ADDENDUM NO. 2

Wayne High School Baseball Field
Fort Wayne Community Schools (FWCS)
Fort Wayne, Indiana
March 6, 2025

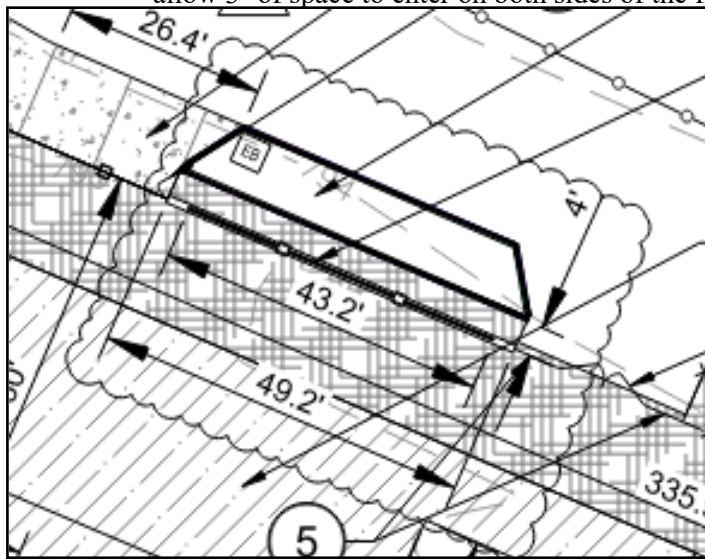
- 1. C201 – 4’ padded guardrail with mesh screening in front of dugouts has been reduced in length to allow 3’ of space to enter on both sides of the fence.

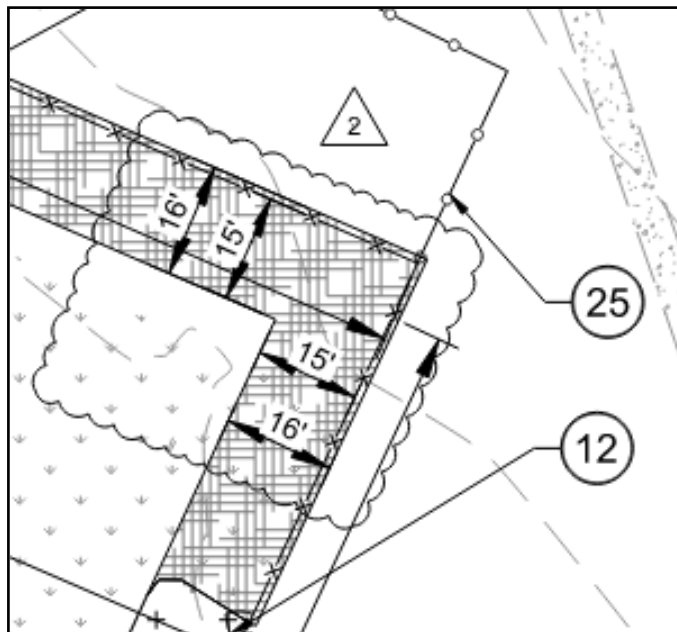
- 2. C201 – Dimensions for proposed warning track has been added to improve clarity

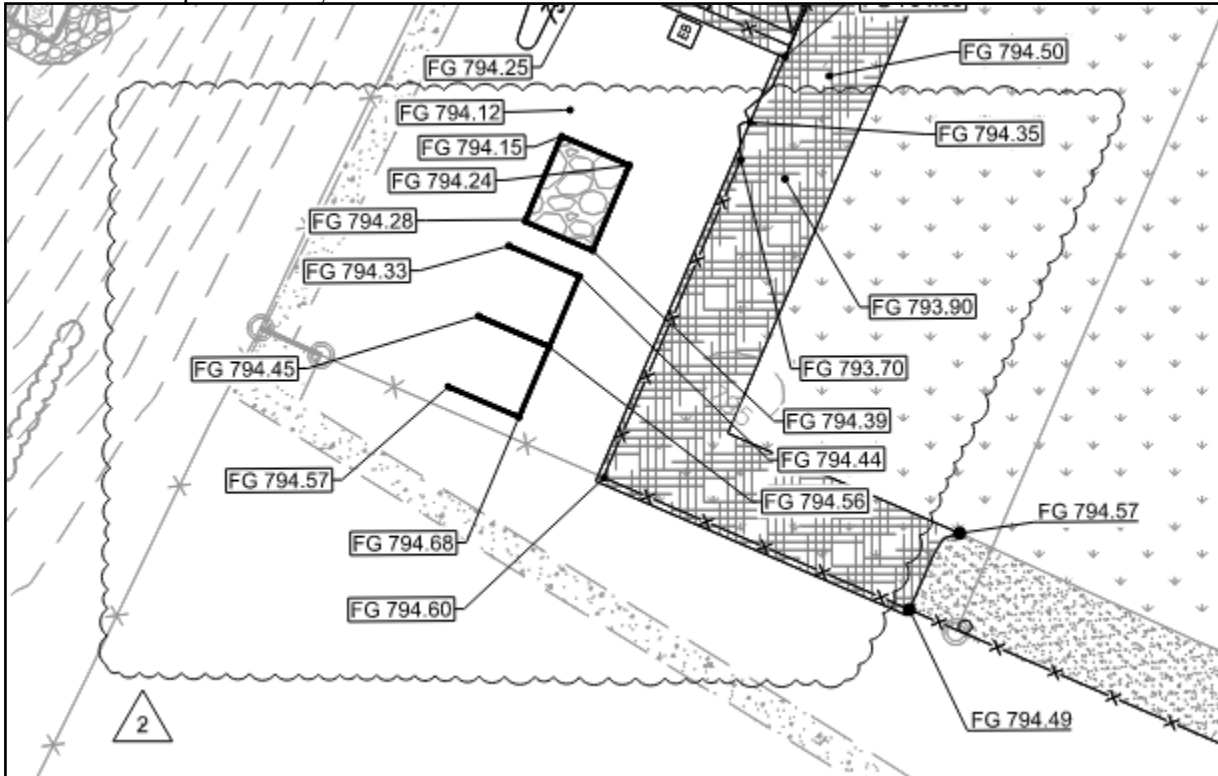
3. C301 – Spot elevations around equipment shed and field material corral have been added to improve clarity.

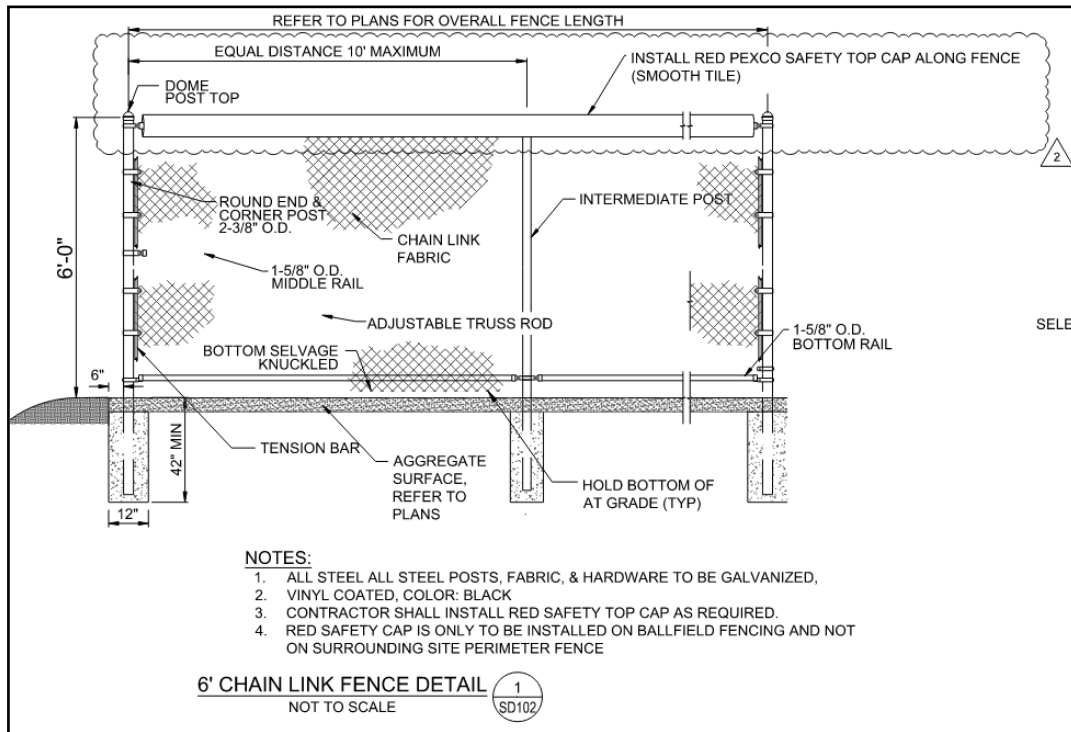
4. SD102 – Detail 1 on sheet SD102 has been updated to show smooth tile red PEXCO safety top cap instead of corrugated tile

1. We are having a hard time finding the red corrugated fence topper?
Please utilize the PEXCO smooth red safety cap
2. Should the dugout fence/railing system be surface mount or direct embed?
The dugout fence/railing should be directly embedded.

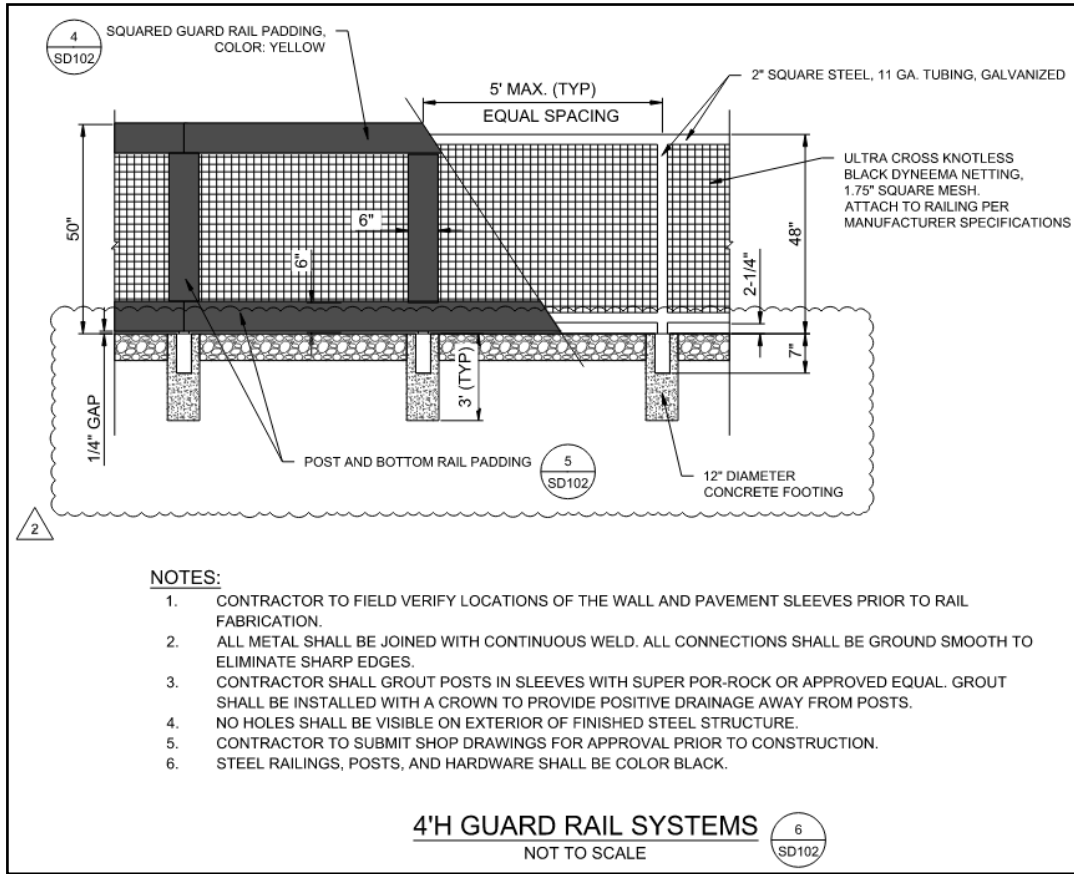
5. SD102 – Detail 6 on sheet SD102 has been updated to show the direct embed foundation as mentioned in Part 4.

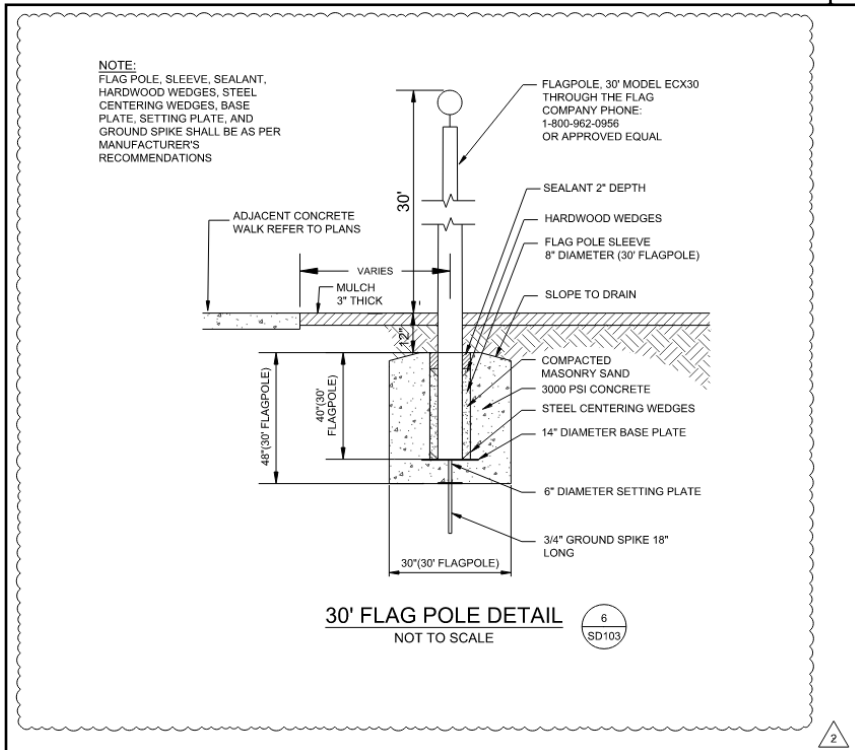
6. SD103 – Detail 6 on sheet SD103 has been added to specify the flag pole and installation
